STATE OF MARYLAND CRITICAL AREA COMMISSION CHESAPEAKE AND ATLANTIC COASTAL BAYS

RE: 718 – 32nd Street Property owner: Sandra Holleger; File # 11109

The applicant and or Town has forwarded the Commission incomplete and incorrect information regarding this project. The following comments are noted and need to be addressed before this permit should move forward:

STORMWATER MANAGEMENT APPLICATION Critical Area 10% Rule Compliance Paying and Additions

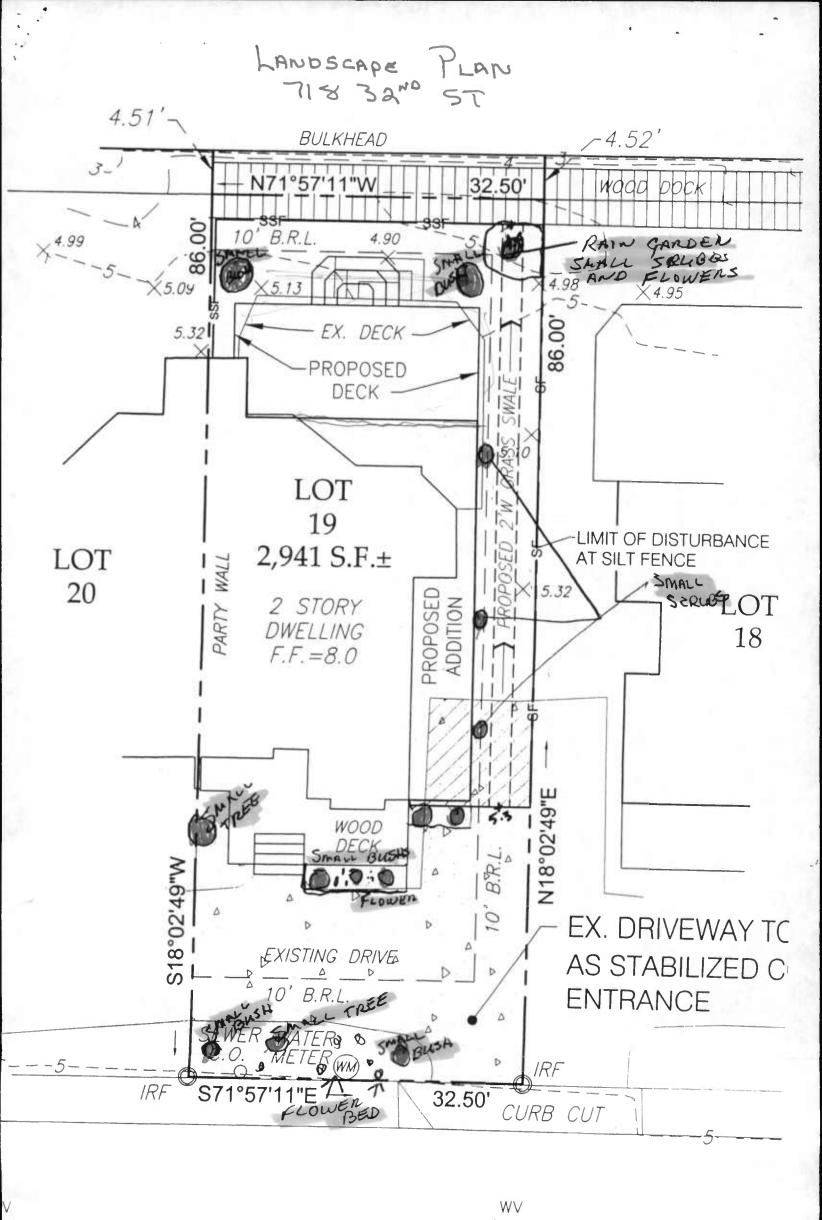
6. The applicant or Town does not acknowledge or address the proposed deck on the plan. This must be addressed.

- Install and maintain silt fence, if needed, until property is stabilized bare soil will need to be stabilized with vegetation, straw, or other appropriate measure prior to Certificate of Occupancy. All disturbed property will be permanently and adequately stabilized including under deck to prevent soil runoff and erosion within 14 days. All stormwater Management structural devices will be protected from siltation until site is stabilized
- For 10% Critical Area Compliance, see attached Residential Water Quality Management Plan and 7. associated BMP's and Landscaping Plan.
- Note all changes shown in red to site plan attached signature here agrees to any changes. S.

The Deck is an existing deck that will be removed and replace according to the deck detail. The only increased impervious surface is the addition of 167 sf. The Stormwater form was changed and the error in the existing impervious surface was corrected on the new form, which the owner and contractor have signed. The Xerox enlargement was for landscaping purposes only and the proposed site plan is to scale.
